SERVICE NOTE

PRODUCT AFFECTED	ASSEMBLIES AFFECTED	DRAWINGS AFFECTED
OB-Xa serial numbers 810602 and before	Lower Control Board

OBERHEIM ELECTRONICS, INC.
ENGINEERING CHANGE ORDER

ECO NO.
102

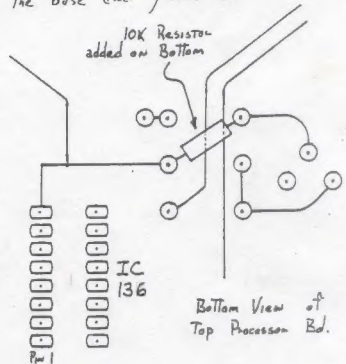
The original value was 6.8uF tantalum. The new value will be 10uF to 22 uF electrolytics. However, the timing capacitor in the cassette interface input circuit requires a 6.8uF tantalum.

A larger value capacitor in this circuit causes improper synchronization of the inputted data.

OB-Xa's with serial numbers 810602 and before may have the wrong capacitor installed.

Replace this capacitor when necessary. Note the polarity when replacing the capacitor.

SHEET 4 OF 4
LOWER CONTROL BOARD

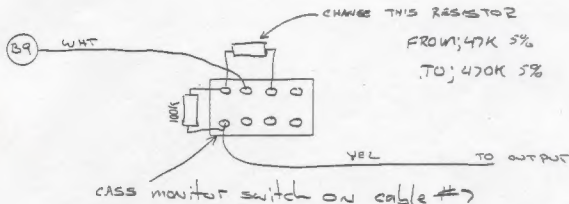
TO LOWER THE VOLUME IN THE "LOW" position of the
cassette monitor switch

1520
VOICE CARD

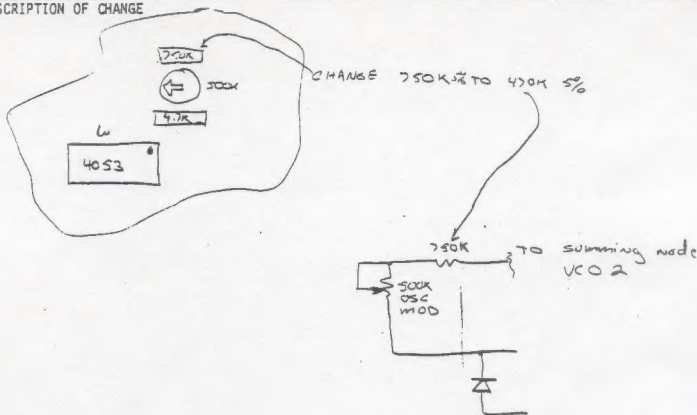
REASON FOR CHANGE TO CENTER OSC MOD TRIMMER, THIS giving a more usable range.

VOICE CARD

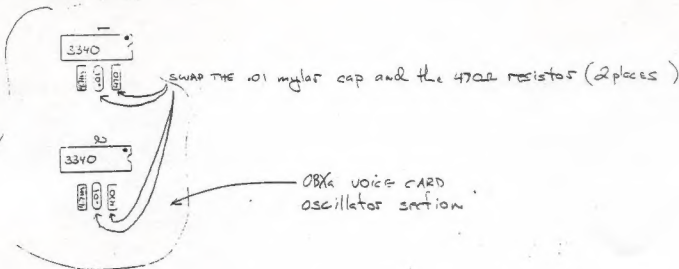
TO ELIMINATE the possibility of the oscillators phase coupling each-other.

OBX_g Mother Board

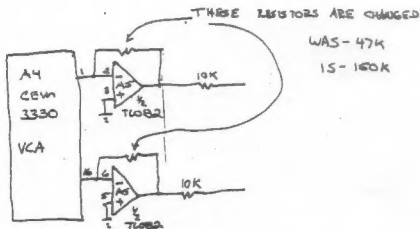
Change 47K 5% resistor to 150K 5%, upper and lower mother boards; 2 places each.

The resistors are located near IC 5 (TWOB2) on both mother boards.

TO INCREASE THE GAIN OF THE OUTPUT VCA CIRCUIT.

OBX_g MOTHER BOARD

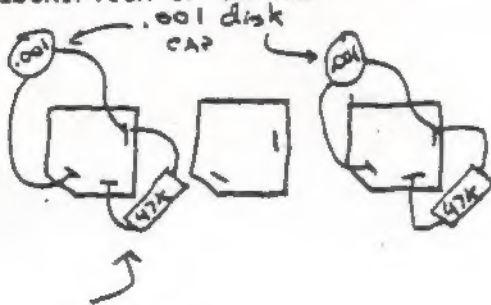
INSTALL TWO .001 disk capacititors from
tip to ground on each output jack
(left and right)

- KEEP LEADS SHORT AS POSSIBLE

- BE SURE TIP OF PLUG CLEARS CAPACITOR
WHEN INSERTED INTO JACK.

REASON FOR CHANGE TO ELIMINATE HIGH FREQUENCY NOISE IN OUTPUT UCA CIRCUIT.

OBXg MOTHER BOARD

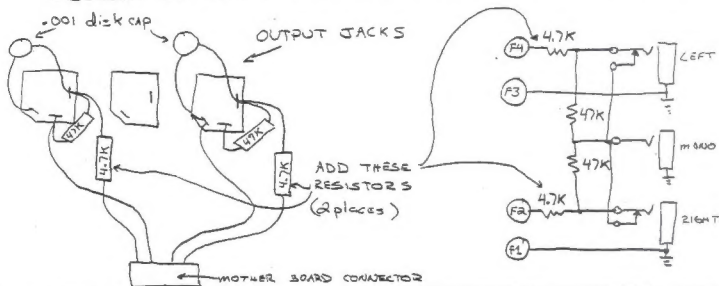
ADD 4.7K 5% RESISTOR IN SERIES WITH EACH OUTPUT
(LEFT AND RIGHT)

- CUT POSITIVE LEAD OF EACH OUTPUT CABLE AT THE JACK TIP
- SOLDER ONE END OF THE RESISTOR TO THE CUT LEAD.
- SOLDER THE OTHER END TO THE TIP OF THE OUTPUT JACK.

TO ELIMINATE THE POSSIBILITY OF 'BLOWING' THE P CHANNEL FET IN THE OUTPUT CIRCUIT, WHEN PLUGGING A CABLE INTO THE OUTPUT JACKS

1516

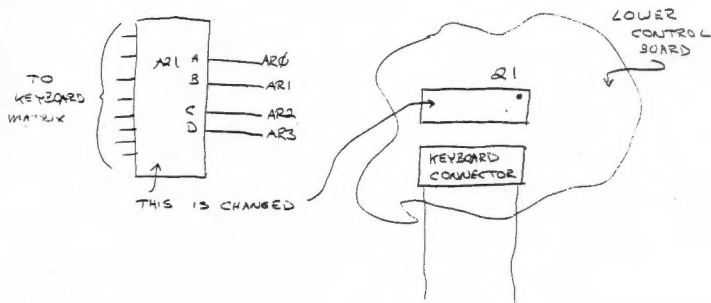
REPLACE 74C42 AT LOCATION A21 TO 74LS42.

ELIMINATE IMPROPER DECODING OF KEYBOARD WHEN PLAYING "TIGHT" CHORDS

OBXa TOP MOTHER BOARD

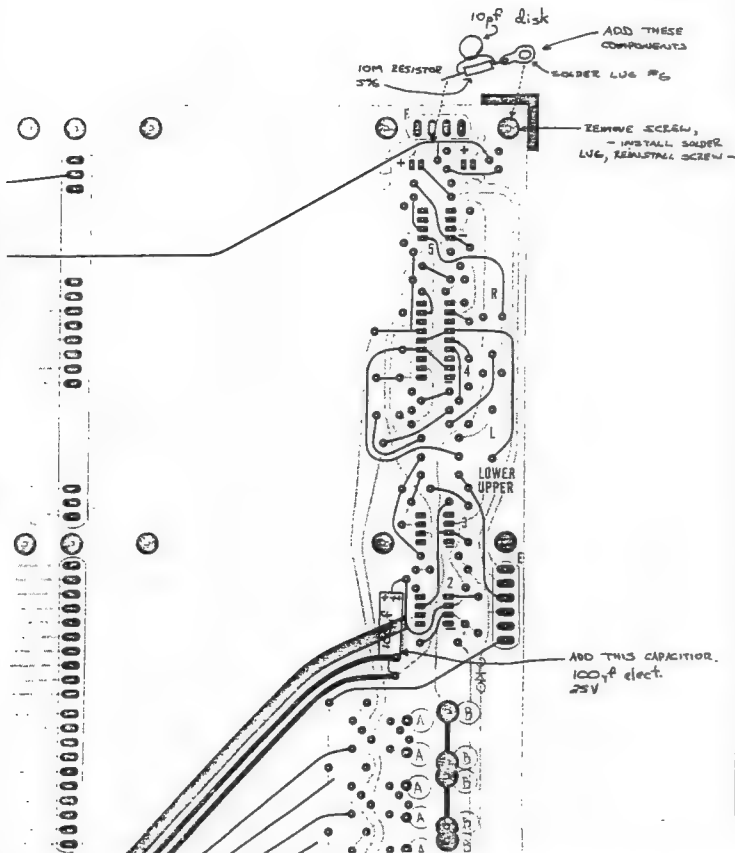
1-INSTALL 10pf disk cap. and 10 M 5% resistor from upper tray ground to PUP line, near J177 FET's. (UPPER MOTHER ONLY)

2-INSTALL 100pf elect. cap from -15V supply to ground. (BOTH MOTHER BOARDS)

3-INSTALL 100uf ELEC. CAP FROM +15 V SUPPLY TO GND. (BOTH MOTHER BOARDS)

TO DECREASE NOISE IN OUTPUT VCA CIRCUIT.

1516 SHEET 4 of 4

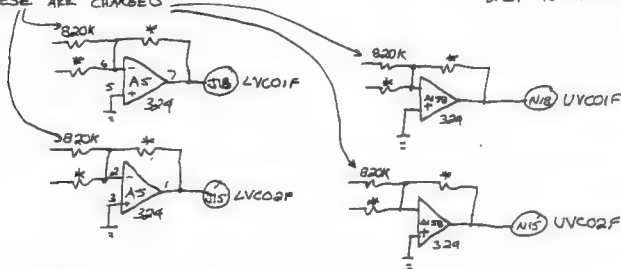
REPLACE 4 820K 5% resistors to 806K 1%. 2EA upper control.
2EA lower control.
THESE ARE CHANGED

TO MATCH THE LFO GAIN BETWEEN VCO'S.

OB-XA MODULATION PANEL
DRAWING NO 1521

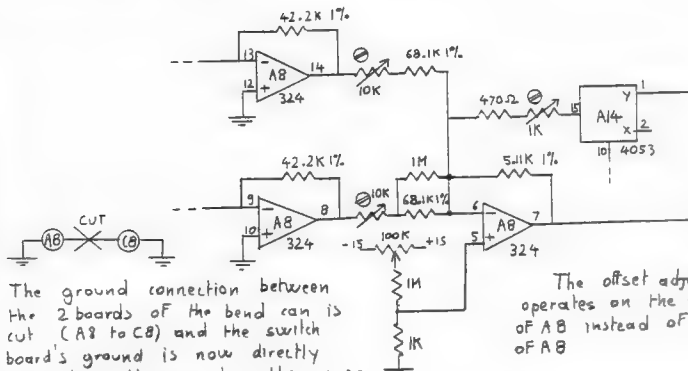
The offset adjustment operates on the + node of A8 instead of - node of A8

Improve the offset adjustments.

1516 SHEET 4 of 4

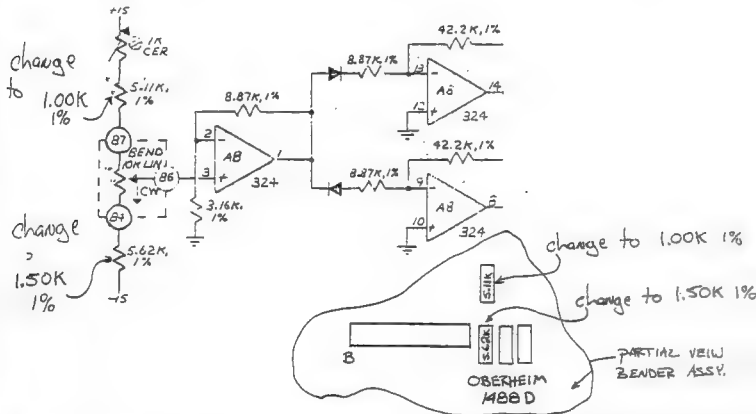
Add signal trace from A12 pin 6 to unused 4053 (A149) Y input on upper control board.

Add signal trace from A152 pin 6 and add trace to A149 (4053) X input.

Add trace from A149 (output) to pins 3, 13 and 1 of A156.

To match the gain of the LFO between voice trays in normal mode (not split or double).

FIG. 1
CIRCUIT

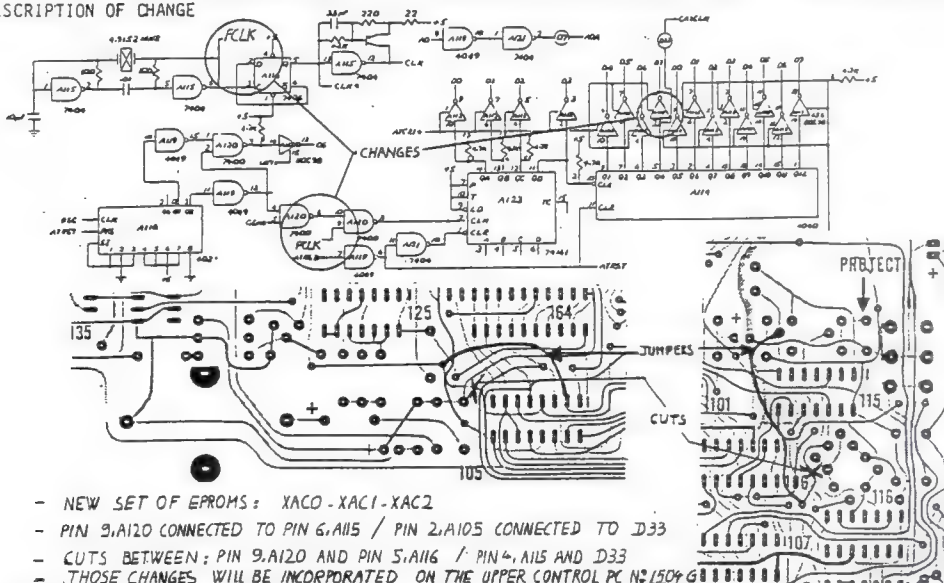
Add wire from pin 12 of A13 to pin 12 of A12, on bottom of modulation PCB.

To help eliminate beeping when OSC2 only is on.

UPPER CONTROL BOARD SHEET 1
N° 1517

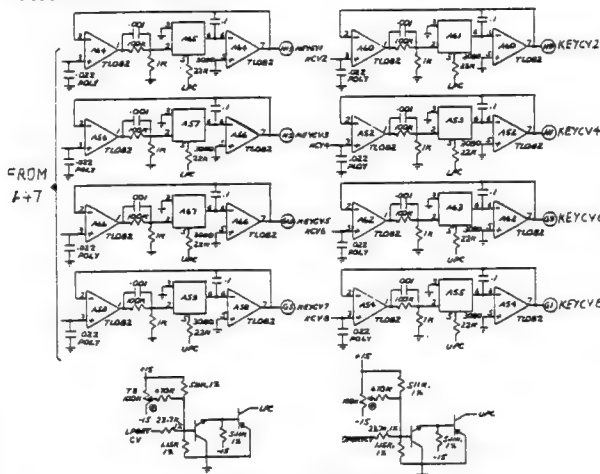
IMPROVE AUTO TUNE

OB-XA LOWER CONTROL 1516 SHEET 3

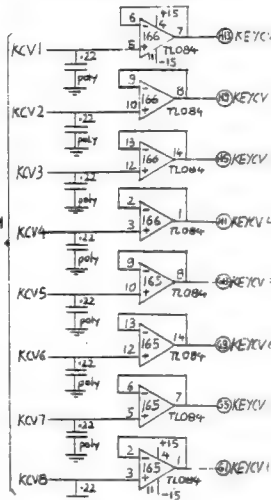
- NEW SET OF EPROMS (2x2732) XADO XADI
- THE PORTAMENTO IS NOW IMPLEMENTED BY THE SOFTWARE

- Improve the portamento speed matching between different voices
- Simplify the analog circuitry

SCHEMATIC-OB-XA VOICE CARD
DRAWING NO 1520A

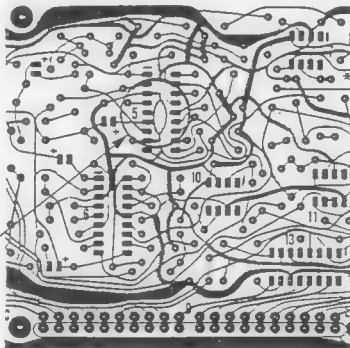
CHANGE 1M 1% (CONNECTED TO *15V
AND PIN 15 OF OSCILLATOR CHIPS)
TO A 750K, 1%. (2 PER CAVL)

TO ALTER INITIAL FREQUENCY TRIMMER RANGE ALLOWING GREATER
PERCENTAGE OF OSCILLATOR CHIPS TO CALIBRATE.

1519 A SCHEMATIC OB-XA MOTHER BD.

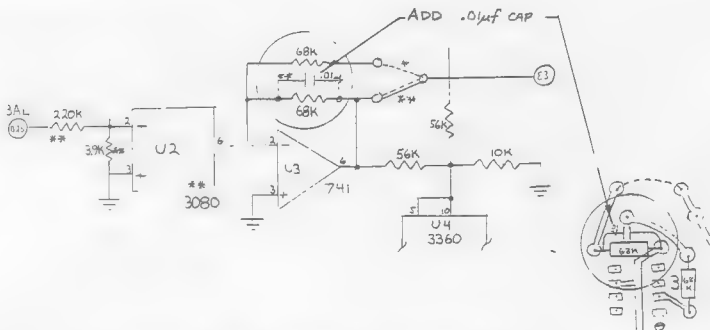
- .01µf capacitor added in parallel to 68K resistor
in U3 feedback network on lower Mother Board (top side)

To eliminate dac stepping noise at the output from the balance control.

SCHEMATIC 1518A (POT 80.)
 ASSEMBLY 720055 (POT BL. #1 XA)

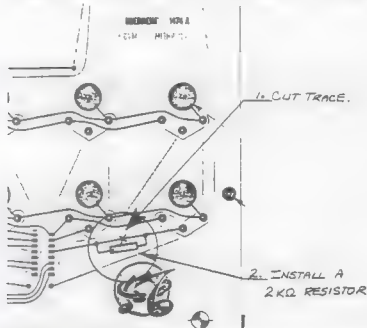
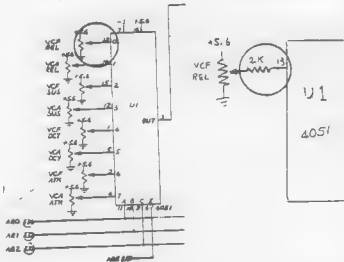
MAKE ONE CUT ON THE TRACE COMING FROM THE SWINGER OF THE VCF RELEASE RT, AND INSTALL A 2 K Ω RESISTOR ACROSS THE CUT. THIS REDUCES CURRENT THROUGH THAT TRACE. NOTE: DO THIS TO UNITS CONTAINING XA-F β (NOT TO XA-FA) AND TO UNITS CONTAINING THE XA-C β , XA-C1, XA-C2 SERIES EPROMS OR BELOW ONLY. UNITS WITH EPROMS XA-G β , XA-G1 AND ABOVE, DO NOT NEED THIS FIX.

AN OPTIONAL HARDWARE FIX FOR XA'S AND 08-X'S THAT HAVE OLD SOFTWARE (2016 EPROMS), CONTAINING AN ERROR WHICH CAUSES NOISE TO BE HEARD WHEN THE VCO PULSEWIDTH CONTROL IS FULLY COUNTER-CLOCKWISE, AND THE VCF RELEASE CONTROL IS FULLY CLOCKWISE.

SCHEMATIC 1517A UPPER CONTROL
ASSEMBLY 720054 "
SCHEMATIC 1516A LOWER CONTROL
ASSEMBLY 720053 "

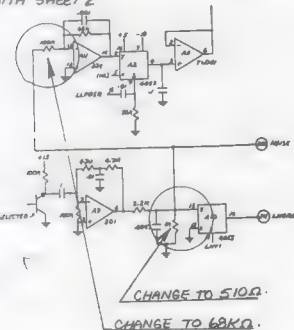
DESCRIPTION OF CHANGE - CHANGE 3 RESISTORS

TO REDUCE THE VOLUME OF THE NOISE FUNCTION

SCHEMATIC 1517A SHEET 2 UPPER CONTROL

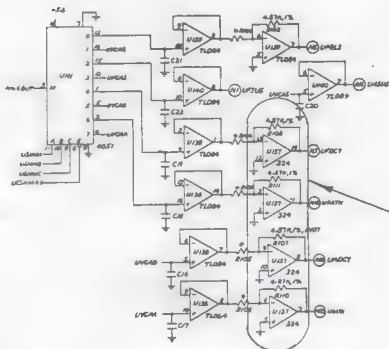
CHANGE U137 FROM AN LM324 TO A TL084.

TO MATCH FILTER ENVELOPE CHARACTERISTICS BETWEEN TOP AND BOTTOM TRAYS.

SCHEMATIC 1510A SHEET 4 (REAR PANEL)
 SCHEMATIC 1519A MOTHER BD.
 ASSEMBLY 720057 & 720057-0 (LOWER)
 ASSEMBLY 720061 & 720061-0 (UPPER)
 ASSEMBLY 750129-1 (XA CABLE #7)

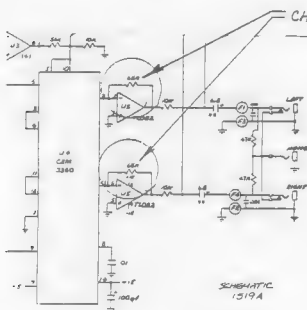
1. CHANGE A TOTAL OF 4 RESISTORS PER 08-XA UNIT
 FROM 68K TO 120K.

2. CHANGE RESISTOR ON CASSETTE
 MONITOR SWITCH (REAR PANEL) TO
 68KΩ. THIS RAISES CASSETTE
 MONITOR VOLUME, KEEPING RATIO
 OF THE VOLUMES OF SYNTHESIZER
 OUTPUT AND CASSETTE MONITOR
 CONSISTANT.

TO INCREASE GAIN OF OUTPUT.

Schematische - 1515

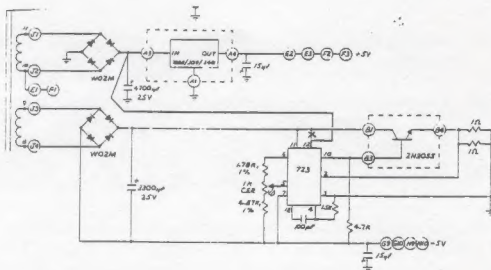
Cut lead going to pin 12 of the -5
723. regulator & run that pin to the
+ lead of the +5 filter cap.

Allow for operation down to 90 VAE input.

SCHEMATIC 1516A LOWER CONTROL 7A

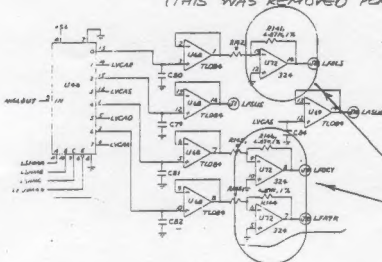
1. CHANGE UT2 FROM AN LM324 (313022) TO A TL084 (313024).
 2. ADD 1 EA: 219902 14 PIN I.C. SOCKET AT LOCATION UT2.**
- (THIS WAS REMOVED FOR ECO #137)

TO ELIMINATE FILTER ENVELOPE NON-MATCHING PROBLEMS
CAUSED BY SENSITIVITY OF 324 TO NOISE.
(SEE ECO #135)
